MEMORANDUM TO: Mayor and City Council
Planning Commission

SUBJECT: Final Staff Analysis
SDP-9896-2024: 10003 and 10009 Fields Road

Bohler Engineering (“Applicant”) submitted Schematic Development Plan (SDP) application, SDP-9896-2024 on August 2, 2024 (Exhibit #1). Application SDP-9896-2024 proposes a 5,106 square-foot car wash facility and associated site improvements. This application was reviewed under the Zoning Ordinance in effect at the time of submission in accordance with § 24-1.2 of the 2024 City Zoning Ordinance Update, “Any application, including any sketch plans, schematic development plans or site development plans included therein, that is submitted prior to the effective date of the 2024 City Zoning Ordinance Update and that is deemed valid and complete and includes all application’s submission shall be reviewed by the planning division, planning commission, city council and all other relevant city agencies pursuant to the standards of the zoning code in effect at the time of the application’s submission, as long as the submission proceeds for review and approval within two (2) years of its submission.”

Exhibit #53e shows the stacking plan.

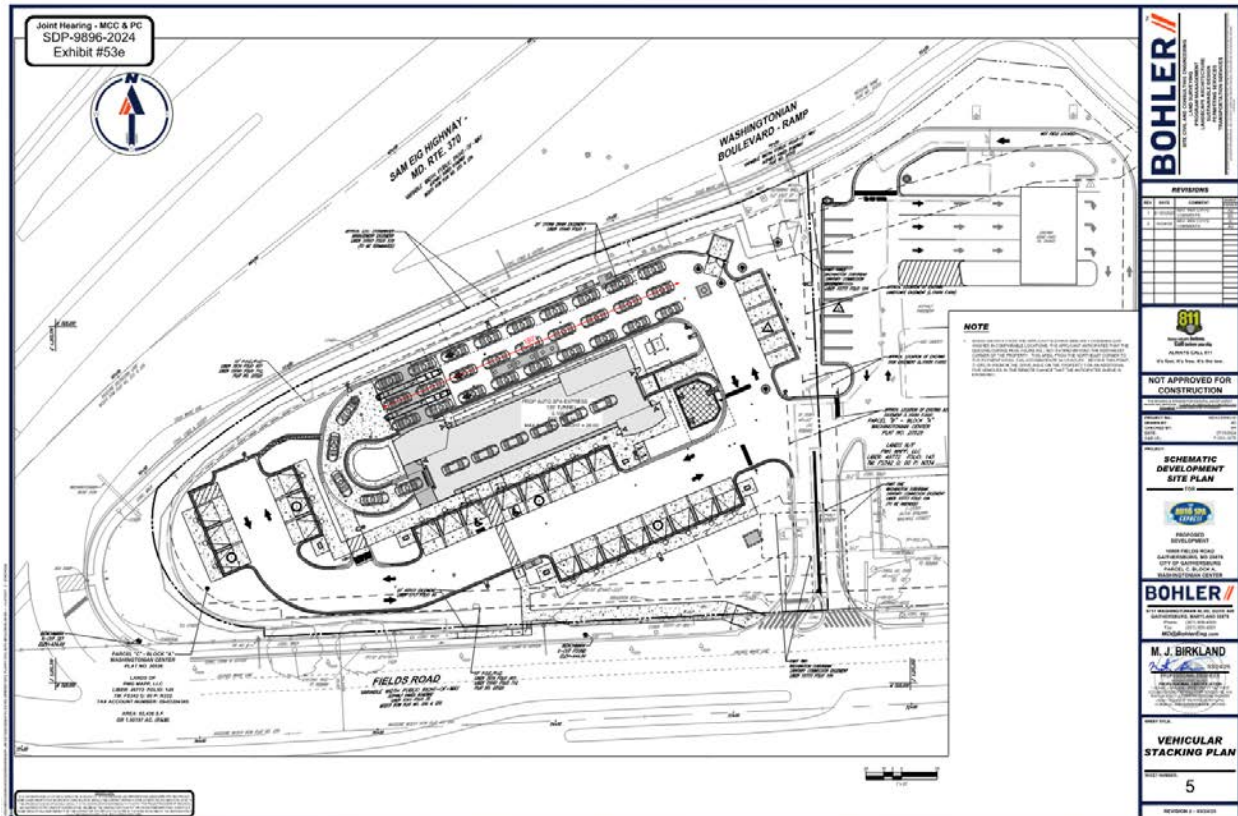
As part of the site plan package, the Applicant submitted a revised vehicle circulation plan to show how vehicles can access the Subject Site. In the plans, it shows that thirty-two cars can fit in the tripled stacked lanes and five (5) cars can fit in the car wash tunnel. During the public hearing, there was discussion about the car stacking and traffic circulation. As noted in the Applicant's response letter, they anticipate that there will be an average of 51 daily carwashes from Monday through Friday and 49 daily carwashes on Saturday and Sunday. There were also discussions about vehicles turning left from Fields Road onto the site and a possibility of allowing a right turn from Washingtonian Boulevard. As noted in the Applicant's response letter, closing the left turn lane from Fields Road into the drive aisle would significantly restrict property access and threaten the viability of the existing gas station, lube center, restaurant, and dry cleaners. The letter

The Applicant’s traffic consultant conducted a Highway Capacity Manual (HCM) analysis that studied the traffic patterns and delays in nearby traffic. Exhibit #51 includes links to videos that show how traffic movements into the site to demonstrate that “there are more than adequate gaps in the traffic to accommodate additional left turns into the Property that will be generated by the carwash customers and will not cause any conflicts between vehicles turning left from Fields Road and vehicles traveling south on Fields Road.”

Staff concurs with the Applicant’s response and finds that the turning movements and stacking plan is acceptable. Staff agrees with the Applicant’s analysis showing that the proposed new trips into the site can be accommodated without any significant negative impact on safety or operations.

Exhibit #55a shows the preliminary forest conservation plan.

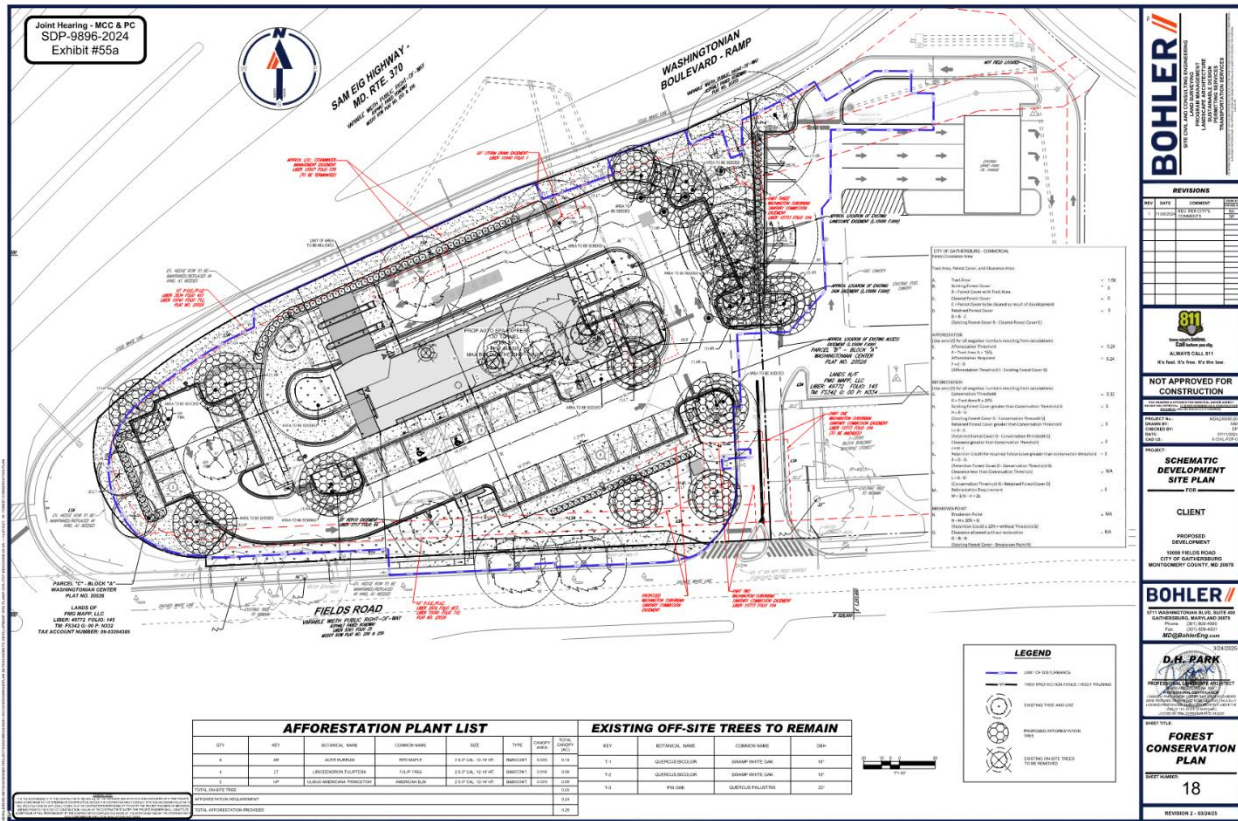
The preliminary forest conservation plan was revised to address previous comments. The Applicant is still proposing fourteen (14) different types of canopy trees, which include red maples (*Acer Rubrum*), tulip trees (*Liriodendron Tulipifera*), and American elms (*Ulmus Americana* 'Princeton'). The project is required to provide 0.23-acres of canopy coverage, and the Applicant is proposing 0.25-acres of canopy coverage, which is a reduction to what was presented during the joint public hearing but still meets the afforestation requirement.

The preliminary landscape plans were revised since the joint public hearing. Instead of 51 sweet pepper-bushes (*Clethra Alnifolia*) and 45 common cherry laurel (*Prunus Laurocerasus*), the Applicant is now proposing 47 sweet pepper-bushes (*Clethra Alnifolia*) and 73 common cherry laurel (*Prunus Laurocerasus*).

Staff is supportive of the preliminary forest conservation plan and landscape plan. The proposed plan will meet the required afforestation requirements. The plan will maintain the existing landscape shrubs and enhance the Property with more landscaping. Staff notes that any proposed landscaping in easement will require approval from the easement holder at the time of final site plan.

Exhibit #54a shows the east and west elevations.

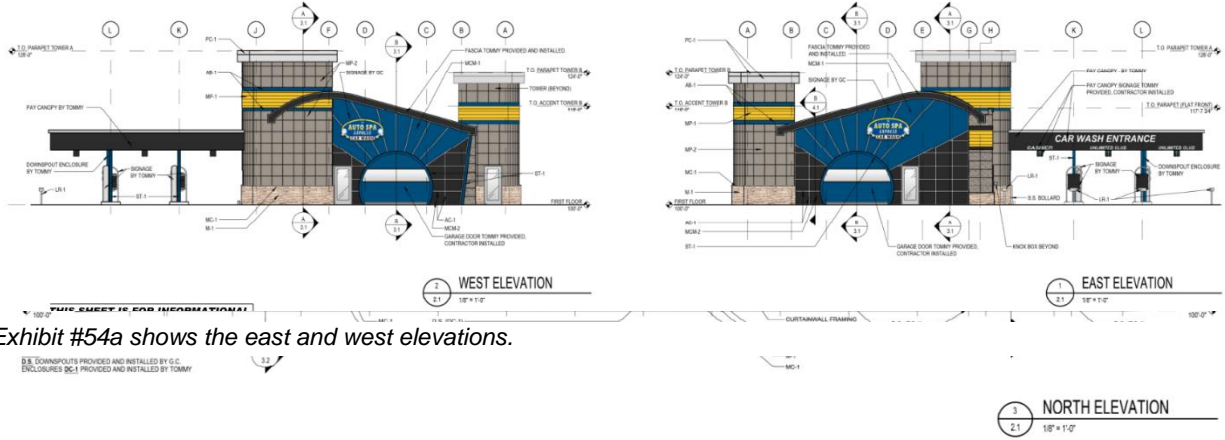
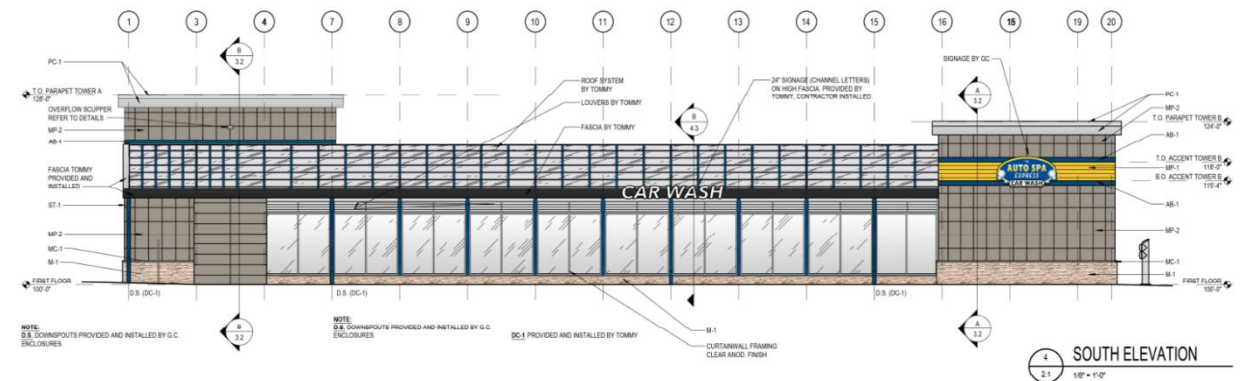
The Applicant has submitted preliminary architectural elevations for the car wash, which have not changed since the joint public hearing (Exhibit #54a-b). The proposed building will be one-story tall that measures 28-feet in height. The proposed facades are pre-finished metal panels, fiber cement panels, glass, and a stone-veneer water table.

Staff supports the preliminary architecture and finds that the Applicant is using a variety of material and techniques to break up the massing of the building. The proposed building will be designed to complement and will be compatible with surrounding buildings.
